Sub-Regional RTEP Committee – Mid-Atlantic PPL Supplemental Projects

April 14th, 2026

Scope Change

Supplemental #: S3781

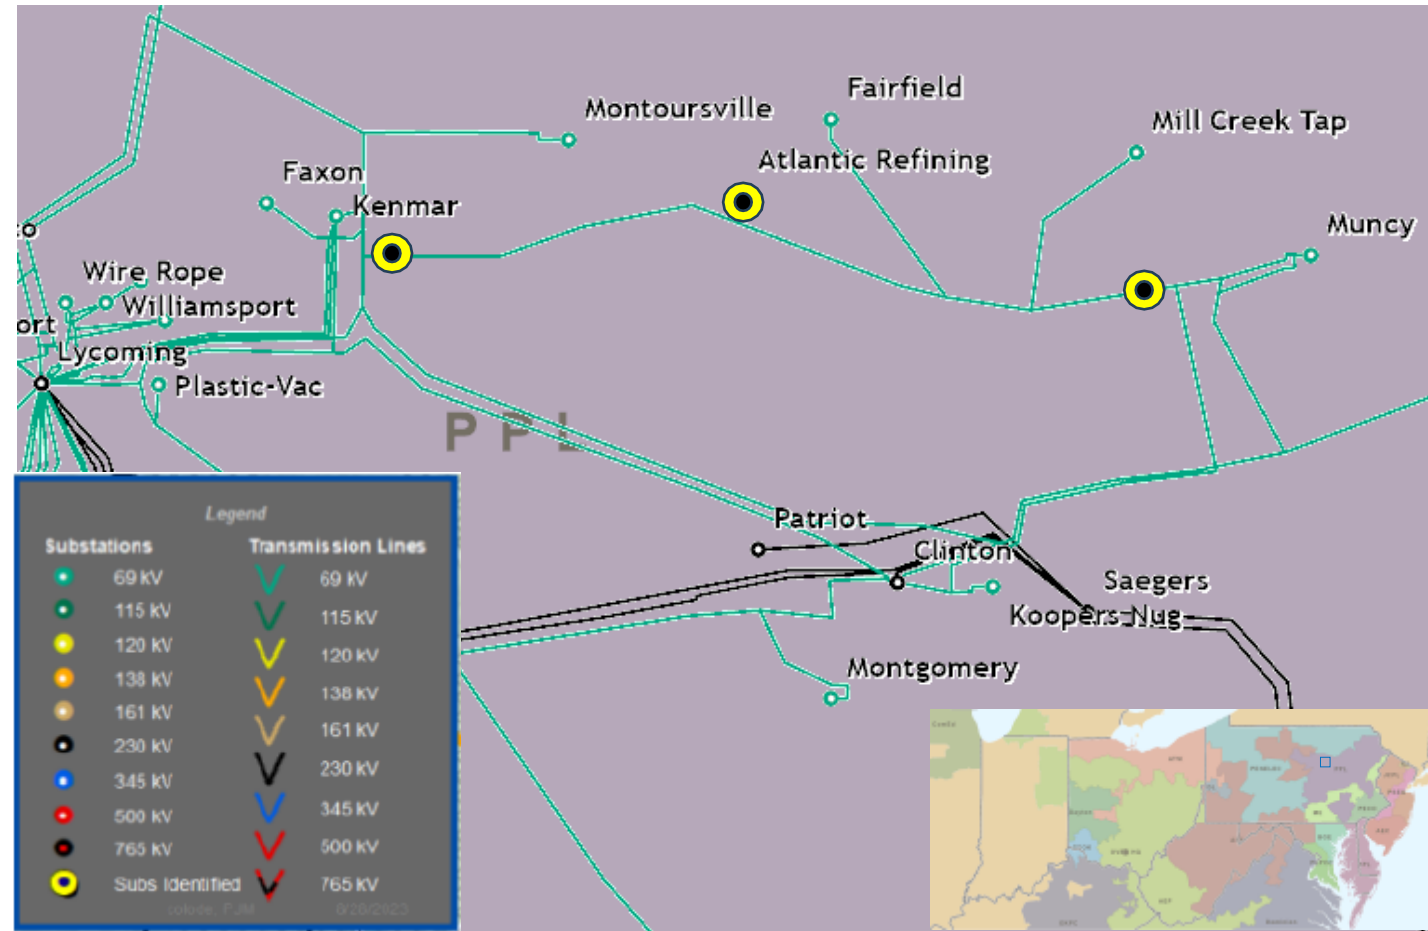
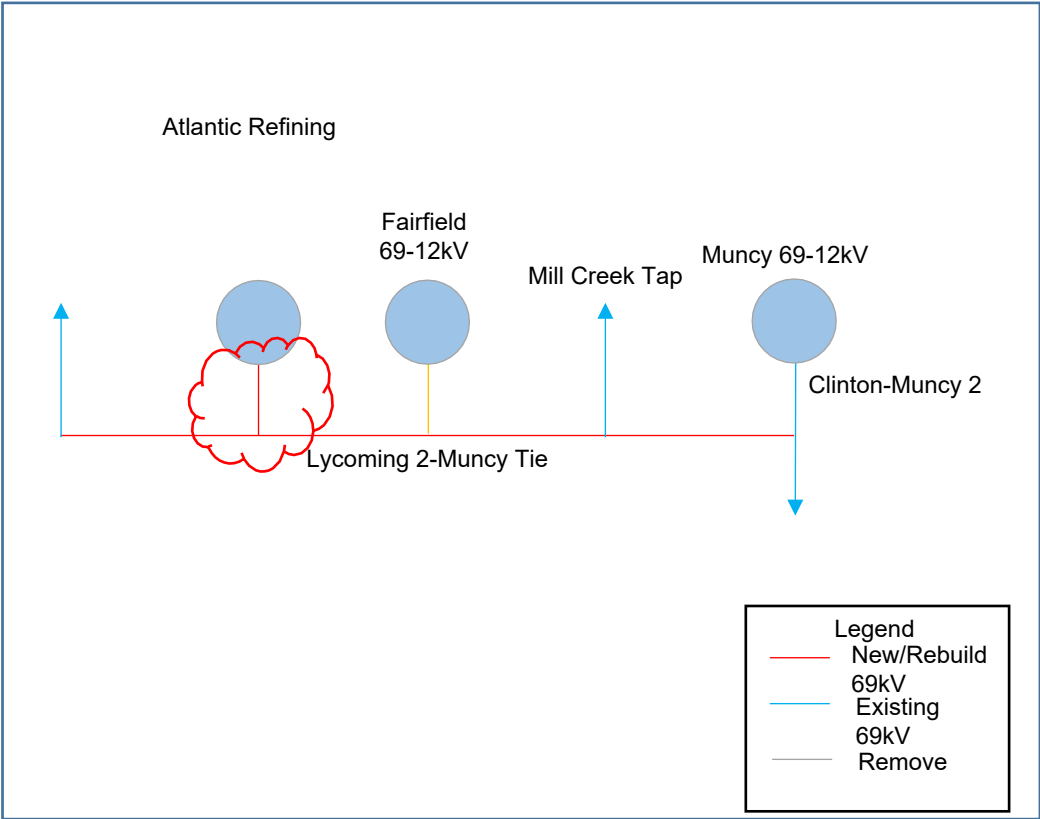
Original Scope:
Rebuild 9.6 miles of the Lycoming 2-Muncy line as single circuit-future double 69kV line.

Additional Scope: Rebuild 0.4 miles of the Atlantic Refining Tap. Utilize 556 kcmil ACSR Conductor.

Transmission Cost Estimate: ~~\$30M~~ **\$31M**
